FINAL DRAINAGE PLAN AND REPORT

16140 OLD DENVER ROAD

PCD File No. PPR-16-037

SUBJECT: Drainage Plan and Report
All About Outdoor Storage PPR-16-037

Stormwater Detention and Infiltration Design Data Sheet

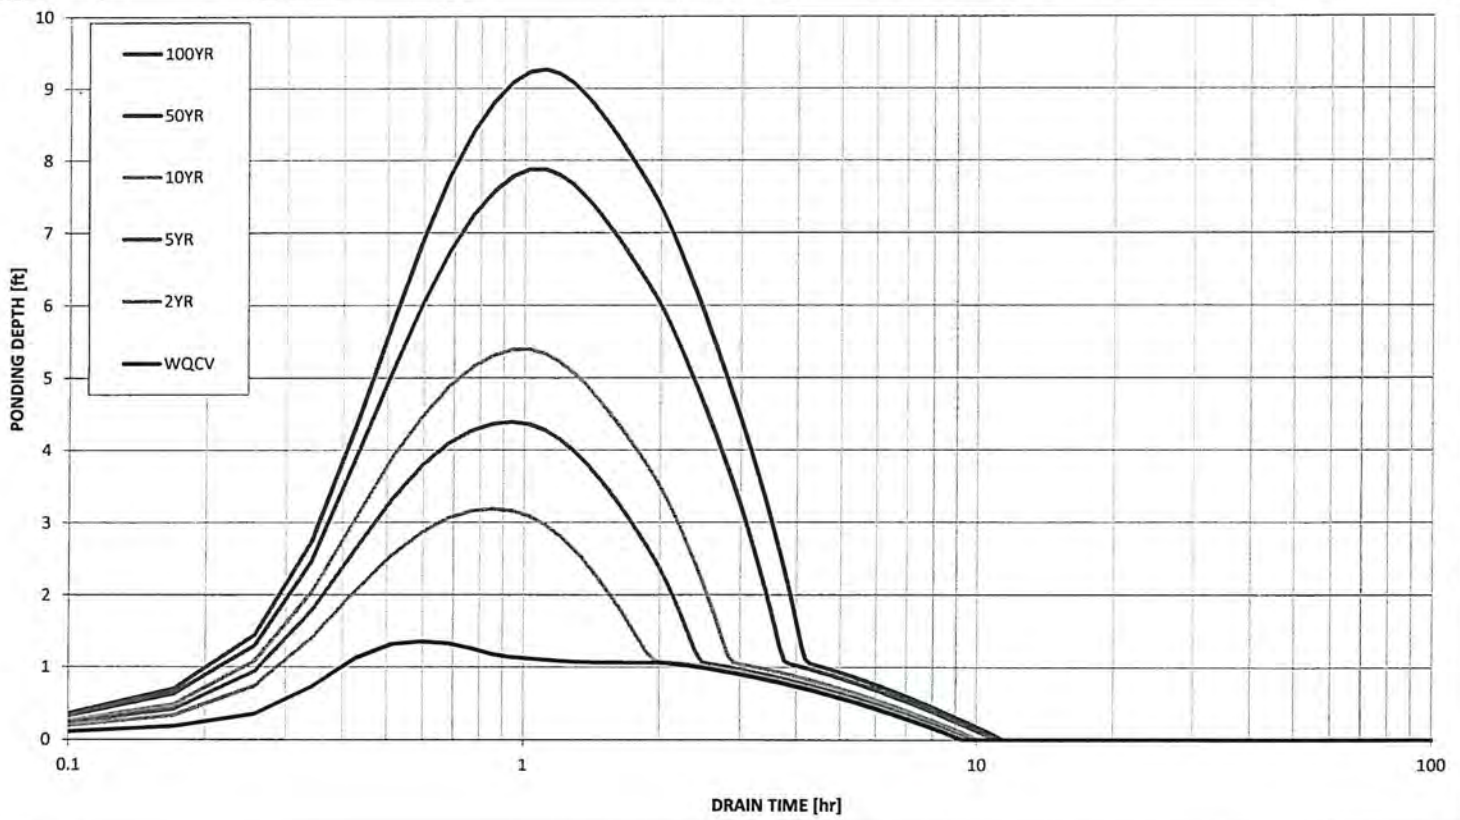
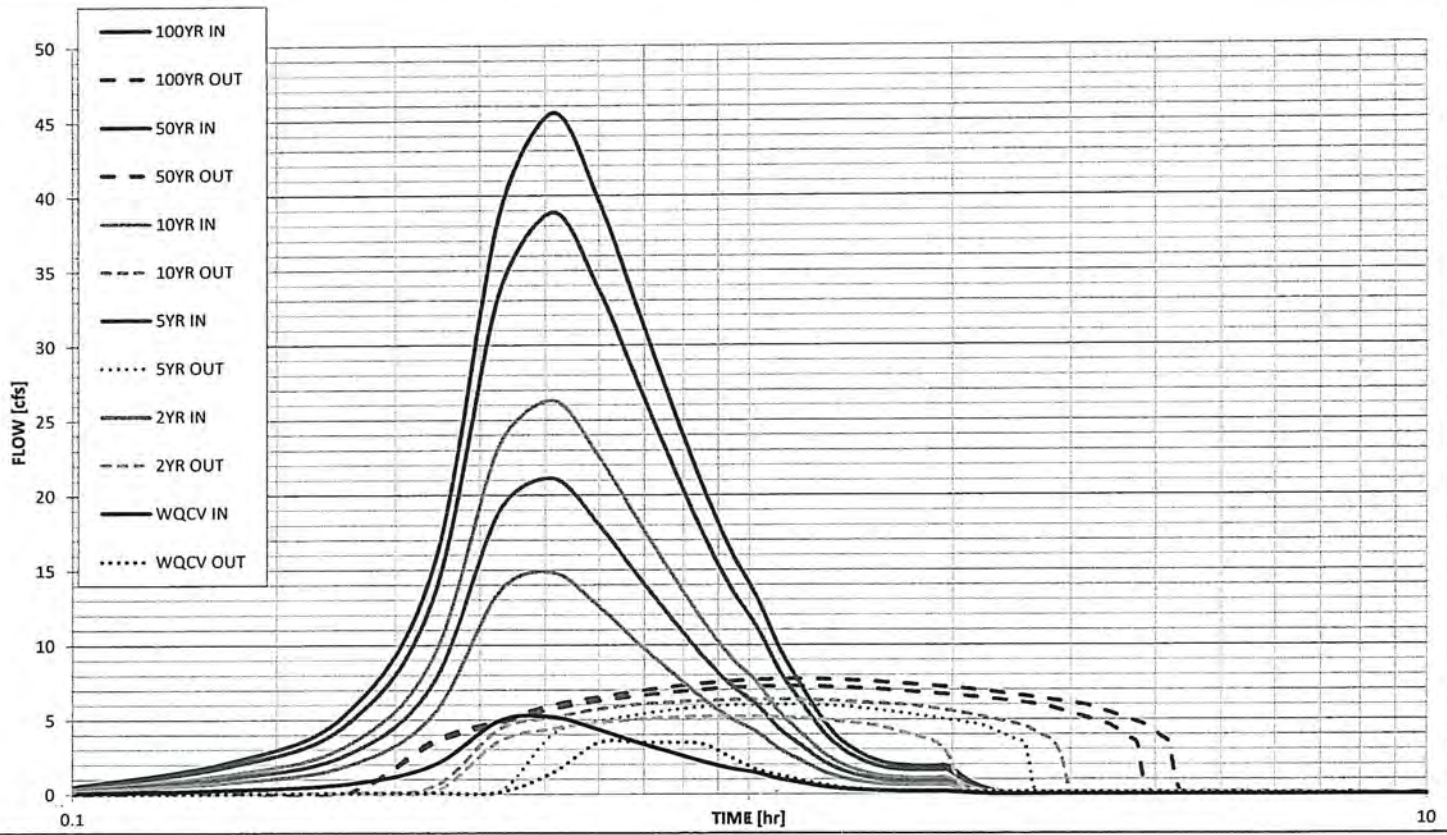
Replace with UD-Detention. Pond design calculation will be reviewed on the resubmittal. Unresolved.

Remove the SDI Worksheet from the drainage report and upload in the dedicated SDI Worksheet slot in the electronic submittal.

Unresolved

PROPOSED POND
AREA CAPACITY

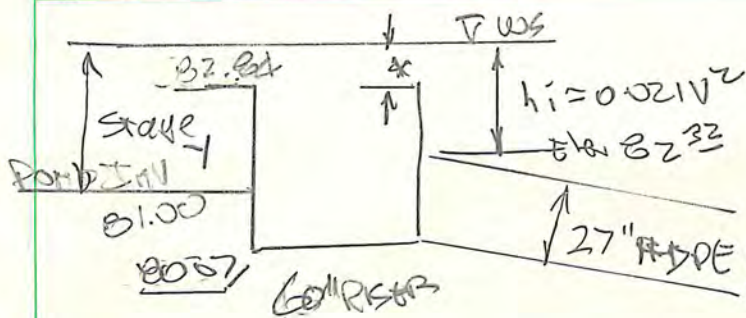
Discuss and analyze from the pond outfall and emergency spillway to the suitable outfall. See ECM Section 3.2.4 for suitable outfall location definition.

Unresolved. This will be reviewed once the UD-Detention worksheet has been submitted. Release rate might be different between the UD-Detention and this calculation.
